Staff Report

Project Name: Coffee Shop and Workforce Development Center
Case Number: COA24-0001
Application Types: Certificate of Appropriateness (COA)
Location: 2506 W Alamo Ave

Request for a Certificate of Appropriateness to allow for a coffee shop and workforce development center site improvements.

Figure 4: Proposed designs on north elevation for ADA ramps, 2506 W. Alamo Ave.

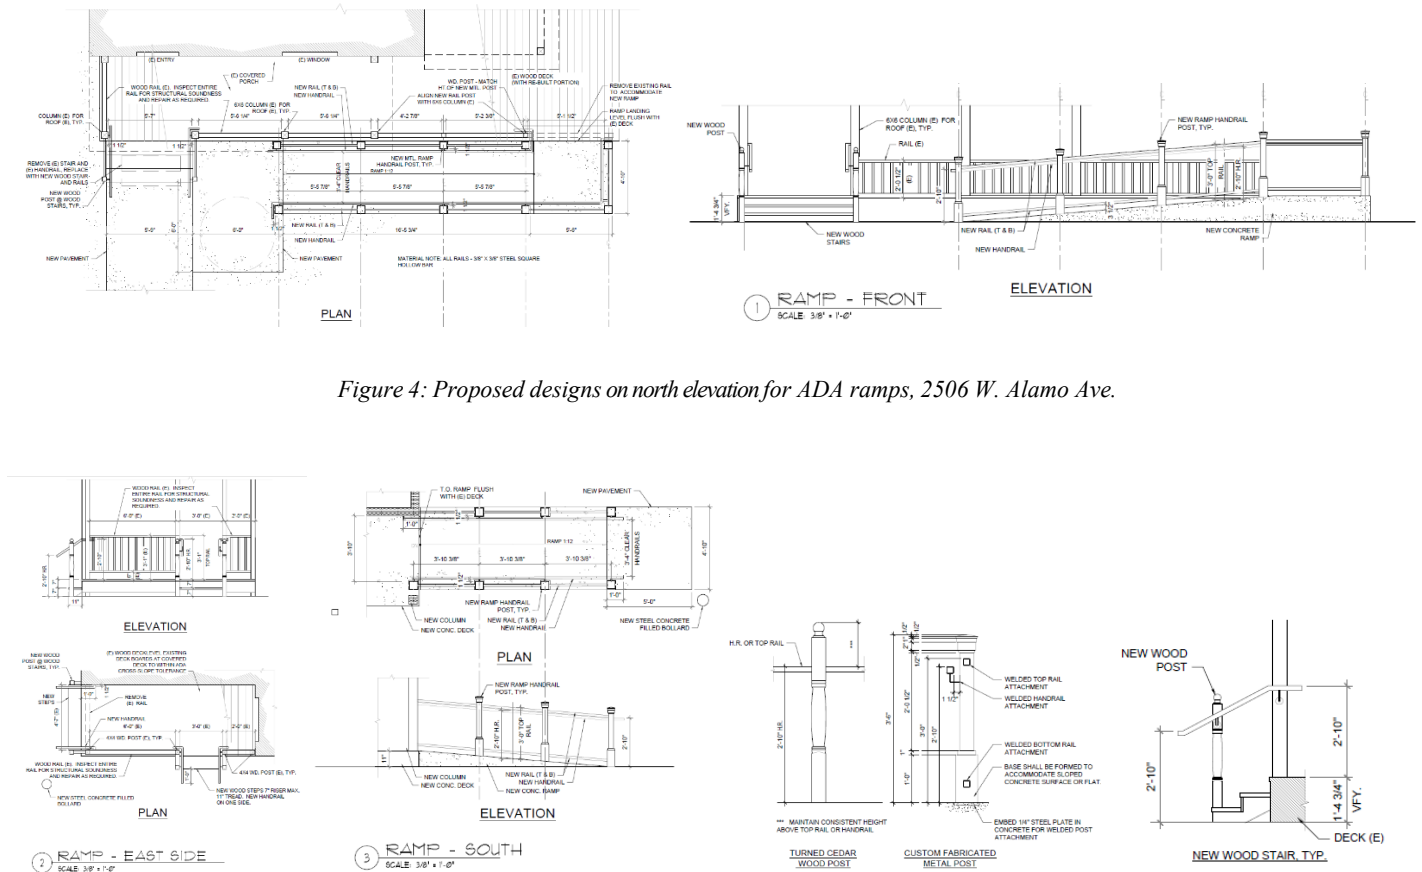
In the elevations referenced above, the proposals show the proposed exterior improvements and additions to the existing structure. The majority of the improvements are related to providing ADA accessibility throughout the site to enable its use as a workforce development center and coffee shop. The proposed ramp on the front façade of the structure would minimally obscure the historic railing portion on the eastern edge of the existing front porch. This proposed ramp would require altering the non-historic deck and railing towards the west.

The work under review with this COA will not include the removal of historic materials. The proposal will affect mainly the front and rear façades. The impact of the proposed ADA ramp to allow direct front access will have minimal impact on the historic front facing façade. The sections of railing that will be removed are not historic and are only to accommodate the ramp and landing area at the western edge of the existing non-historic deck. Small steps will be rebuilt due to safety concerns. The new materials will be used in a similar fashion that will not diminish the building's character. This standard appears to be met.

Figure 9: Proposed designs on south elevation highlighted, 2506 W. Alamo Ave.

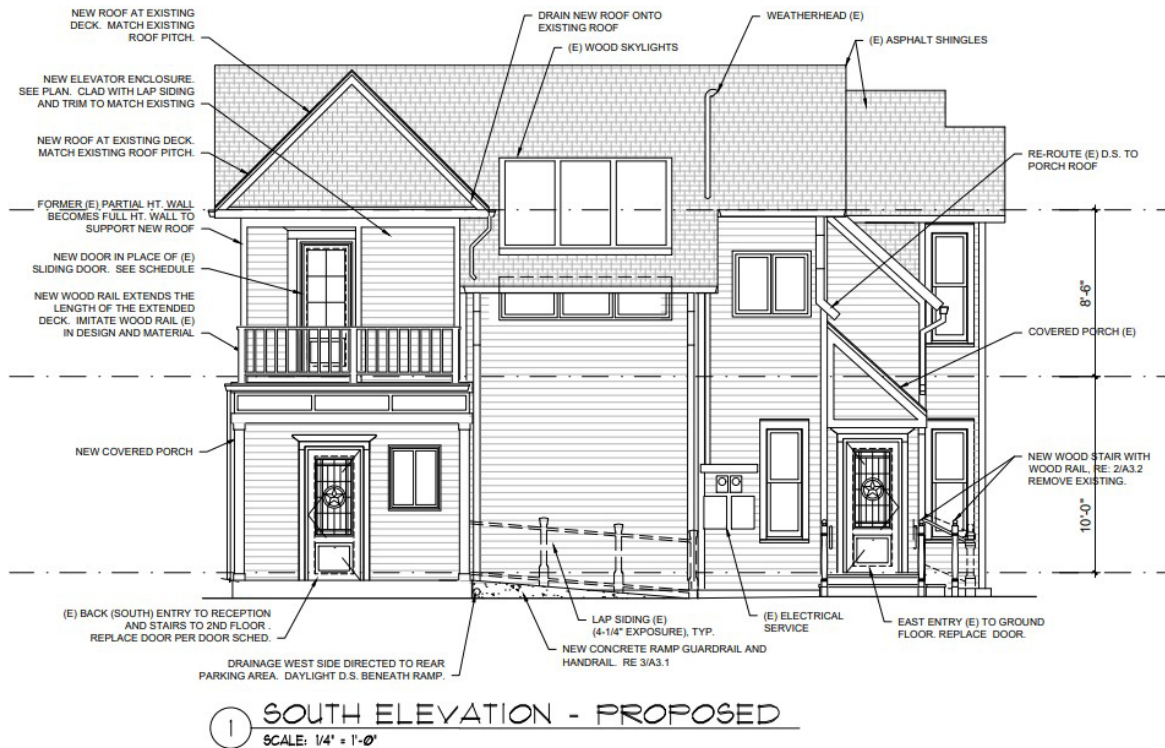
None of the proposed changes create a false sense of historic development or include conjectural elements or architectural elements from other buildings. The options for proposed work are modern and not conjectural. The applicant worked with staff to provide a design for the rear porch addition that would be consistent with the design of the building without mimicking any historical features. The addition will allow the upstairs to have complete public access and enable its renovation into a workforce development center and provide a covered entry way at the rear. This standard appears to be met.

- i. 3.27 Preserve the original roof form of a historic structure.
 - 1. *Proposal includes changes to the roof form of the rear of the structure, which will not be easily visible from the street and has been modified in the past. The angles of the roof line reference the existing home and do not add inappropriate architectural elements to the structure.*
